UNITED STATES PATENT AND TRADEMARK OFFICE

Office Action Summary

10/063,288

DETAILED ACTION

FIG. 6.

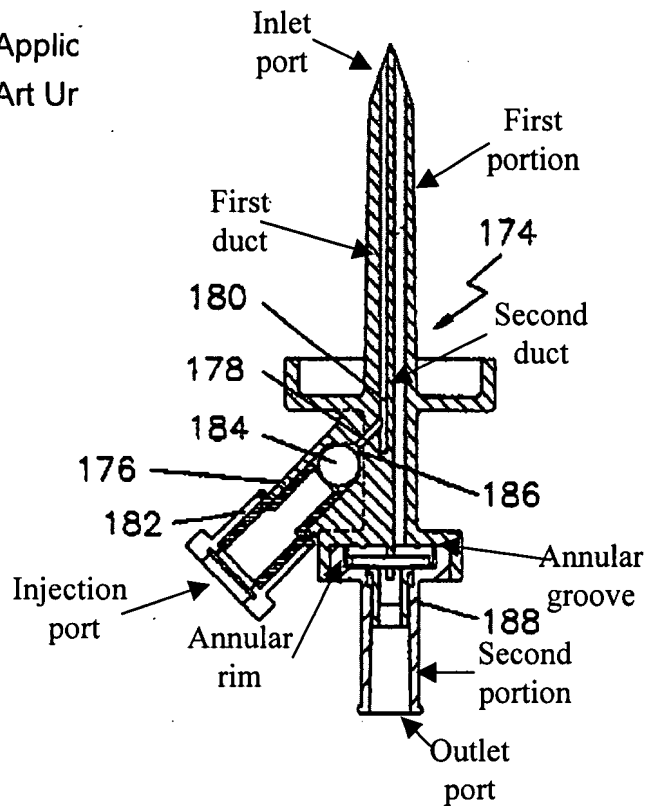
In the specification and figures, Richmond discloses the device as claimed by applicant. With regard to claims 1 and 9, Richmond discloses a device that is capable of mixing medical fluids comprising ports that may be used as an inlet port, injection port, and outlet port, respectively (see drawing, as annotated by Examiner, below, FIG 6). The device comprises a first duct 180 that extends between the inlet port and the injection port, and a second duct that extends between the inlet port and the outlet port (see FIG 6). The injection port comprises a hydrophobic, or fluid-proof membrane 182 that is capable of being penetrated by another device (see column 6, lines 18-53). The device further comprises a first portion that houses the inlet port and the injection port and a second portion that houses the outlet port. Richmond illustrates that the portions are separate through the use of diagonal lines, indicating that the portions may be made of different materials.

With regard to claim 21, Richmond discloses that the connector comprises a first portion, second portion, hydrophobic membrane, and a cap or removable hood (see FIG 6, column 3, lines 23-33).

10. Applicant argues that Richmond fails to disclose that the components of the device may be made of different materials. However, as noted in the Office Action, Richmond illustrates first portion 188 with one pattern of diagonal stripes and the second portion with a second pattern of diagonal stripes, indicating that the materials may be different. Applicant asserts that the Richmond disclosure teaches that the pieces are likely made from the same material because they are bonded together, which teaches away from the present invention. However, Examiner is not asserting that the Richmond device alone teaches the use of different materials in a multi-piece

connector. Examiner is using that particular figure of the Richmond device to show that the pieces are separate, providing the possibility that they may be formed of different materials, as taught by Wood.

12. Applicant argues that the recitation of a friction-fit and snap-fit coupling in the independent claim includes structural components. However, this is not the case. The structural components of a snap fit coupling include a protrusion coupled with a groove that snap into place. Applicant discloses such a snap connection 111, 112 in paragraph 0029 and FIG 3, but fails to set forth any structural limitations that distinguish the instantly claimed invention from the prior art. Apparatus claims cover what a device is, not what a device does. See MPEP 2114. Applicant points to Richmond's disclosure of bonding the pieces together to teach away from a friction fit. However, Richmond's disclosure with regard to the bonding applies to the embodiment shown in FIG 2, and Richmond is silent as to the type of connection of the embodiment shown in FIG 6. Therefore, it is the position of the examiner that the structural limitations of the claimed
